Access Compliance Report

Public Rights-of-Way

(Curb Ramps)

Intersection ID: 8047	Main Street: N_HOSKINS_RD	Cross Street: ROZZELLES_FERRY_RD	Location: W
ADA ID: 4D92E9CE96A3	Ramp Type: Perp	Initial Pass/Fail: Fail	Overall Compliance: No
Severity Score: 8.75			
Codes/Mitigation Info/Possible Solution		Field Measurements/Component Compliance

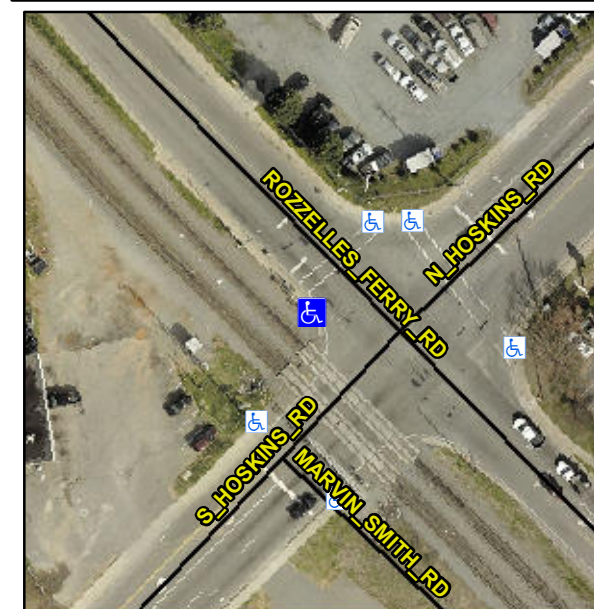
Not Found, R304.5.1

Compliance	Description	Data	Compliance	Description	Data
N/A	Ramp Length (in)	60.0	Yes	Ramp Slope (%)	5.3
No	Ramp Width (in)	47.5	Yes	Ramp XSlope (%)	0.6
N/A	Flare Type LT	N/A	N/A	Flare Type RT	N/A
N/A	Flare Slope LT (%)	N/A	N/A	Flare Slope RT (%)	N/A
N/A	Flare Traversable LT?	N/A	N/A	Flare Traversable RT?	N/A
N/A	Landing Length (in)	N/A	N/A	DWS Provided?	N/A
N/A	Landing Width (in)	N/A	N/A	DWS Contrast?	N/A
N/A	Landing Slope (%)	N/A	N/A	DWS Length (in)	N/A
N/A	Landing X Slope (%)	N/A	N/A	DWS Full Width?	N/A
N/A	Landing Curb? (Y/N)	N/A	N/A	DWS Offset (in)	N/A
N/A	Shared Landing?	N/A			
N/A	Gutter Ponding?	N/A	N/A	Gutter Slope (%)	N/A
N/A	Gutter Lip Ht (in)	N/A	N/A	Gutter X Slope (%)	N/A
N/A	Painted X Walk1?	Yes	N/A	Painted X Walk2?	N/A
	X Walk 1 Direction	To NE		X Walk 2 Direction	N/A
N/A	X Walk 1 Width (in)	78.0	N/A	X Walk 2 Width (in)	N/A
	X Walk 1 Slope (%)	0.1		X Walk 2 Slope (%)	N/A
	X Walk 1 X Slope (%)	1.0		X Walk 2 X Slope (%)	N/A

Remove & Replace Entire Ramp.
